APPENDIX D

Consultation Record

Project Title	Pear Tree Solar Farm
----------------------	----------------------

Meeting Title	Hydraulic Modelling Discussion
----------------------	--------------------------------

Figure 1: Locations on the River Hull which intersect the red line boundary for the site where breaches are not proposed.

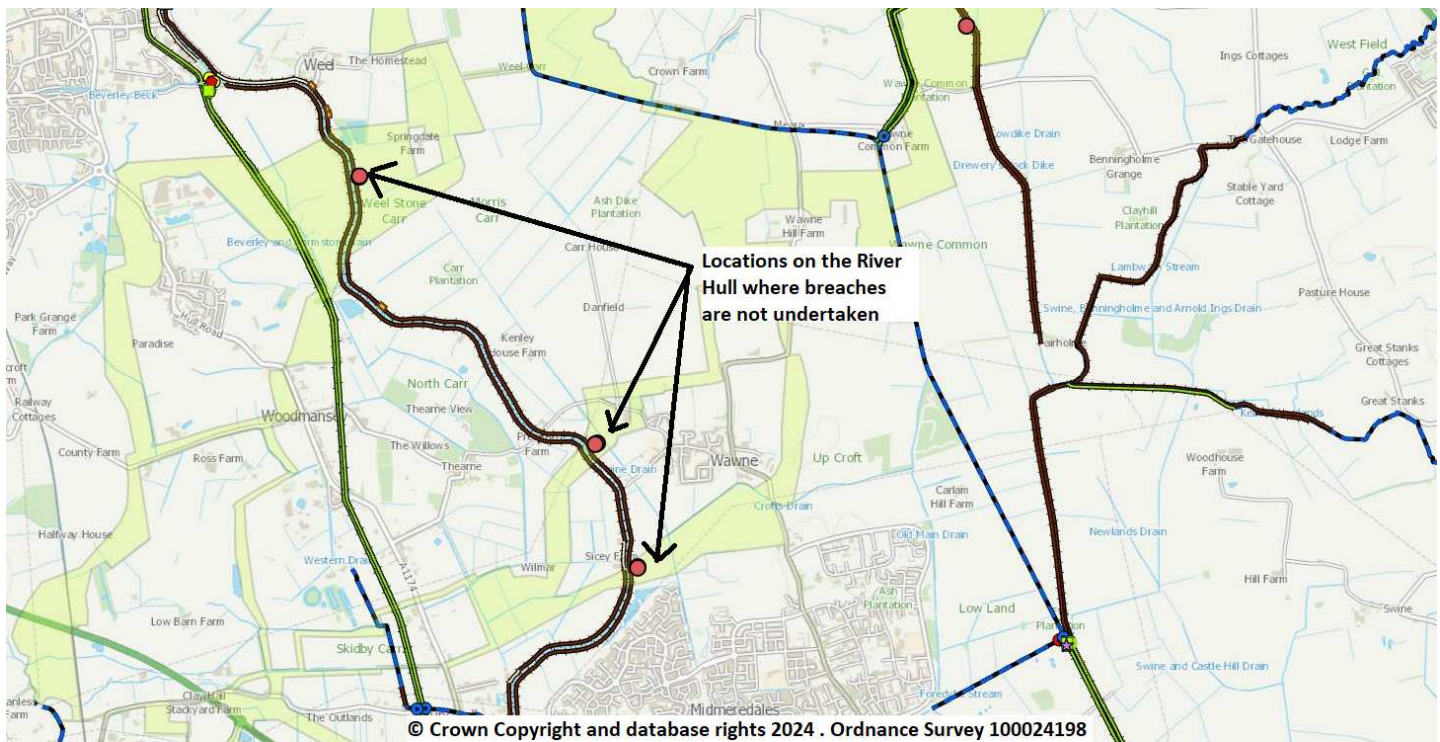
What was the rationale for not undertaking a breach at east 506700 north 438725, east 508280 north 436920, and east 508565 north 436090 on the left and right bank of the River Hull (figure 1 below)? Is this because these are relatively low risk areas for cable routing?
